## Report to Planning and Environment Committee

**Subject:** Masar Development Inc. (c/o Abdul Zaro)  
1208 Fanshawe Park Road East  
City File: Z-9539, Ward 5  
Public Participation Meeting

**Date:** September 18, 2023

Figure 4. Concept Site Plan (August 2022)

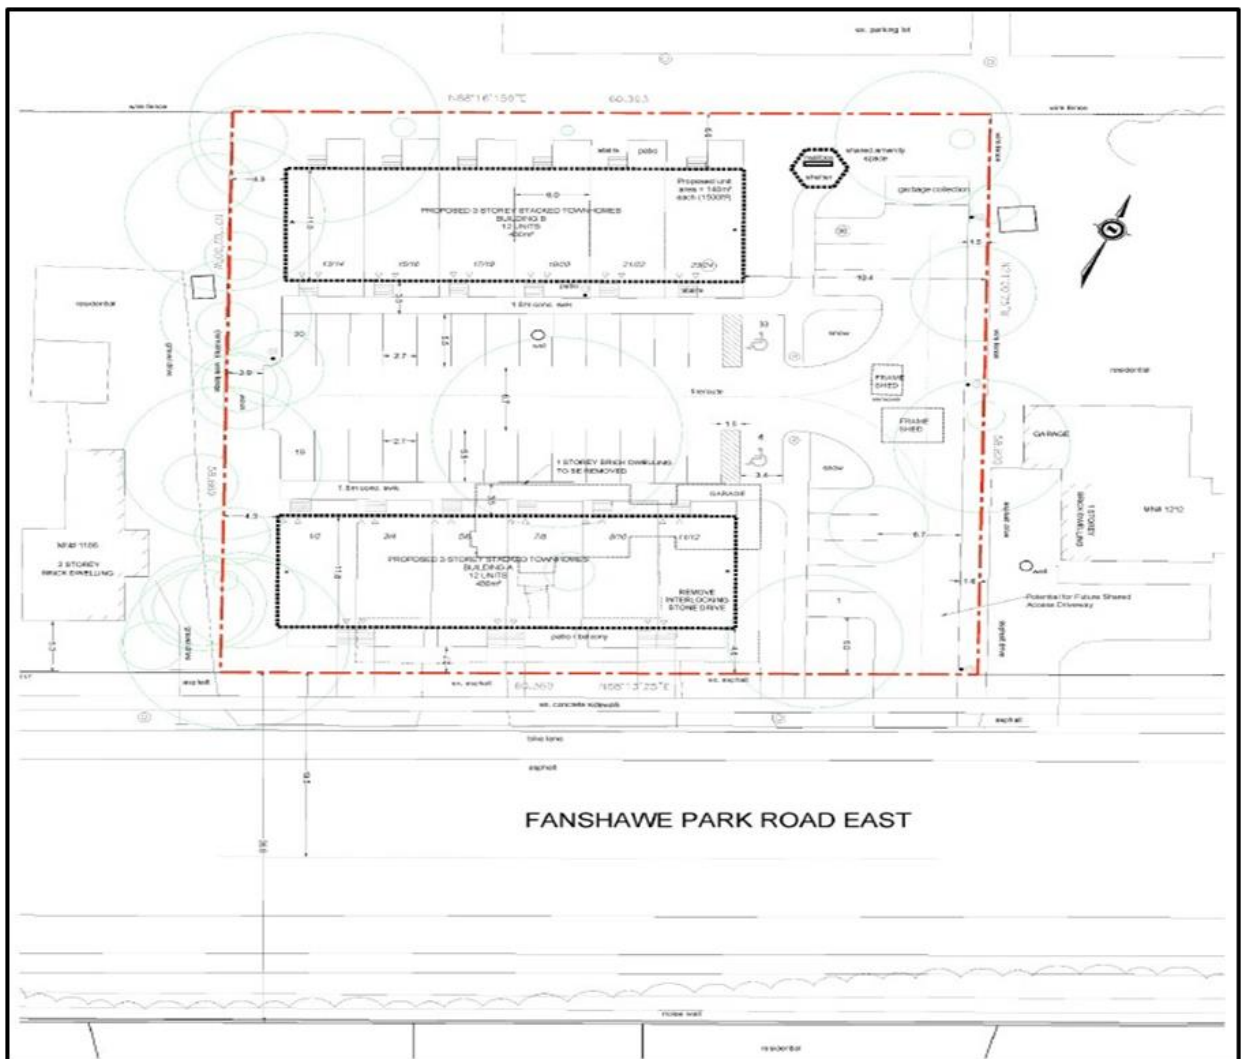
<b>Comment:</b>
<p>The panel has some concerns with the organization of the site as currently shown. Currently the proposed amenity space is hidden at the north-east corner of the site behind a permanent garbage storage area. The proposed two rows of townhouses have</p> <p>a front-to-back relationship. We suggest consideration of the following:</p> <ul style="list-style-type: none"><li>a. Could the stacked townhouse row facing Fanshawe Park Road have both facades designed as front façade with unit entrances?</li><li>b. Could the landscaped amenity space be relocated to the middle of the site between the two rows of townhouses, with parking re-distributed or moved underground?</li><li>c. At a minimum we suggest relocating the amenity space to the west edge of the site away from the garbage area. If parking layout is to remain as shown, we recommend including more planted islands and landscape buffers to soften the character of the interior of the site.</li><li>d. We recommend that the permanent garbage pick-up area should be as subtle as possible. Consider the provision of earth bins. Consider additional landscape plantings to screen and soften the garbage pick-up area.</li><li>e. We recommend provision of a flush paved walkway running north-south across the parking lot to connect the paved walkway from the street through to the paved walkway for townhouse entrances at the rear of the site.</li></ul>

<b>Applicant Response:</b>
<ul style="list-style-type: none"><li>a. Due to the elevation of the initial floor level and the spatial constraints of the site, the site does not allow for the incorporation of rearward stairs/entrance. If the stairs were to be relocated internally, the basement bedroom would not meet the OBC required headroom.</li><li>b. The applicant is willing to re-locate amenity space to the west side of the parking area away from the garbage collection area. The garbage collection is</li></ul>

- c. Amenity space will be moved to the west of the parking area and the parking layout to remain the same as shown. Applicant will facilitate further landscape design where feasible as part of Site Plan approval.
- d. The applicant is already complementing Molok/Earth Bins for the site and will look into screening/landscaping solutions to minimize visual impacts to be detailed as part of the Site Plan process.
- e. The applicant will provide north-south pedestrian connection to the west of Building A to the amenity area and further north to Building B to facilitate more pedestrian circulation opportunities.

Figure 8. Revised Site Concept Plan (June 2023)

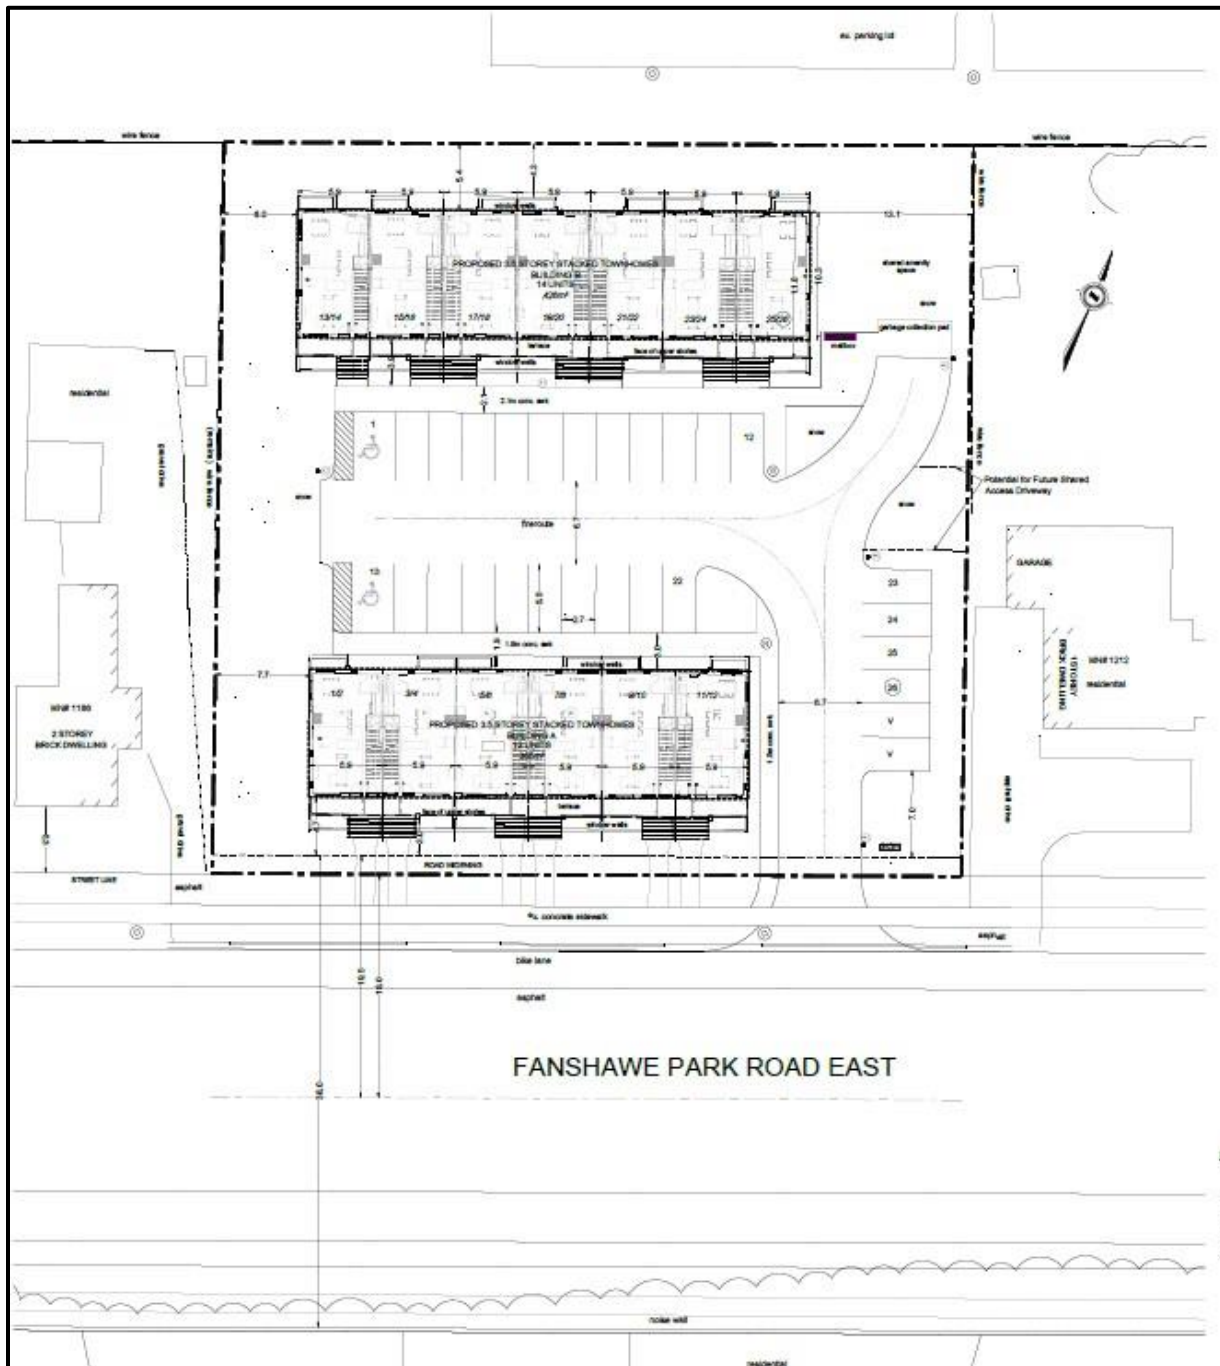
- ii. Additional tree plantings will be required to compensate for loss of trees;
  - iii. Relocate and screen the garbage collection pad away from the shared amenity space and consider providing private outdoor amenity space at the rear of Building B;

- iv. Retain the walkways from each stacked-townhouse unit entrance to Fanshawe Park Road East,
  - v. Consider consolidating walkways to minimize impermeable surfaces and provide a wider shared walkway connection to the sidewalk along Fanshawe Park Road East;

- vi. Screen any surface parking exposed to a public street with enhanced all-season landscaping, including low landscape walls, shrubs, and street trees;

- vii. Provide additional landscaping or other measures to mitigate noise and lights from Fanshawe Park Road for the basement units located within Building A;

- viii. Include short-term public bicycle parking in the development.
